# 269C™ HELICOPTER

ASB B-308A

Revision A • August 4/15

**SUBJECT:** MAIN ROTOR AND CONTROL SYSTEM – Pilot's Collective Pitch Control Stick - One-Time Inspection of Collective Pitch Control Torque Tube

NAS1738 PROPER RIVET MATERIAL IDENTIFICATION MARK  
FIGURE 5

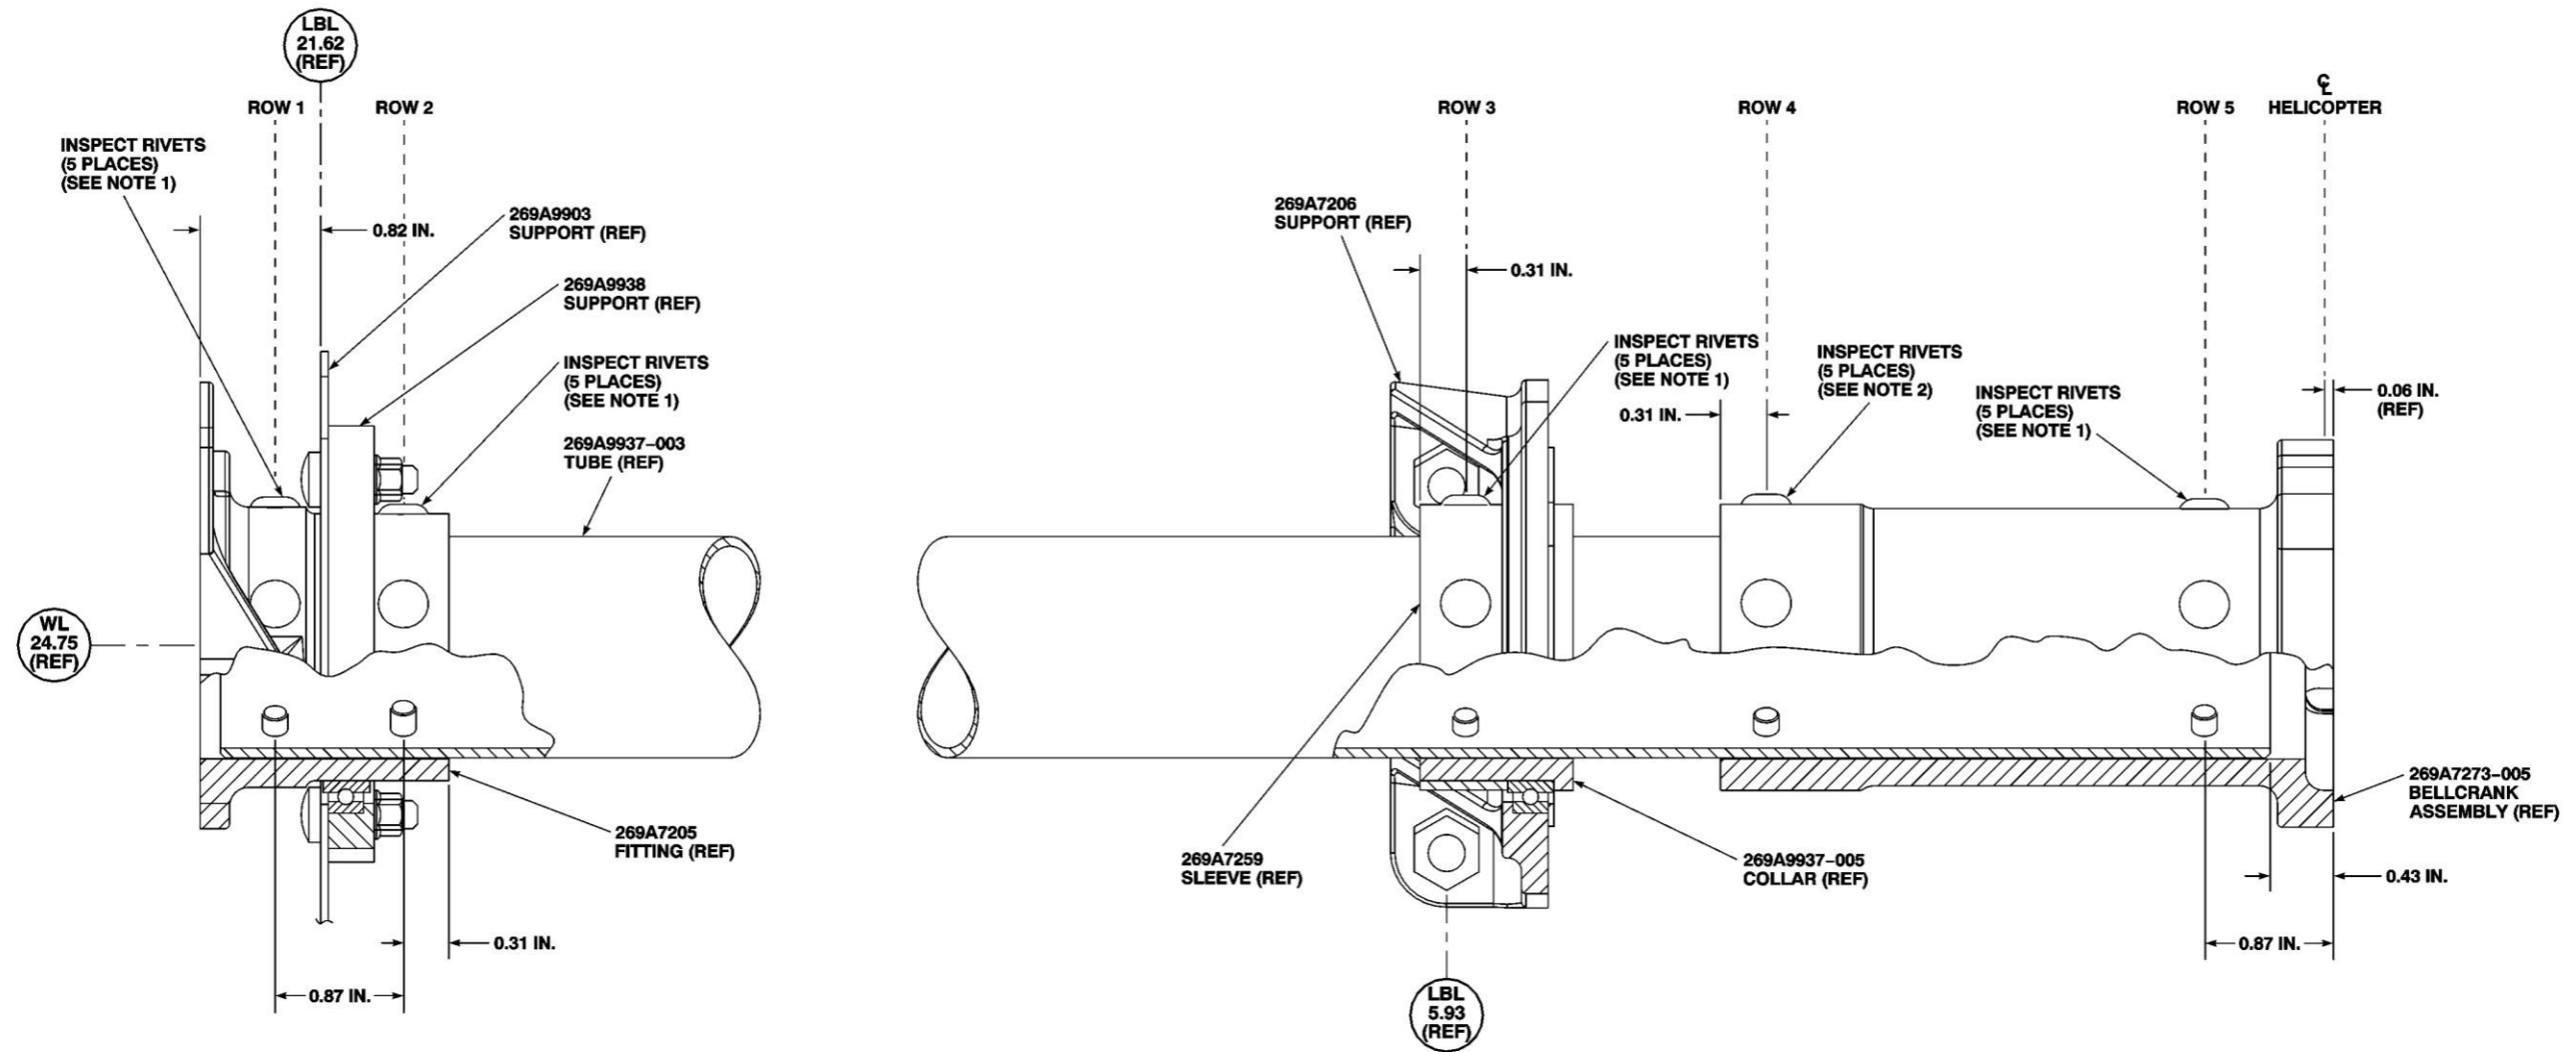
Added new step B.(2) to inspect NAS1738B5-5 rivets.

Added new Figures 5 and 6.

- (2) Inspect at least three of the most accessible rivet heads in row for presence of grip identification on rivets (if NAS1738B5-5). (Refer to Figures 1, 5, 6 (Row 4), Temporary Revision No. 269I-A-4, Torque Tube Installation, and Temporary Revision No. 269I-A-5, Torque Tube Installation, or Temporary Revision No. 269I-C-10, Torque Tube - Collective Pitch Control, and Temporary Revision No. 269I-C-11, Torque Tube - Collective Pitch Control.)
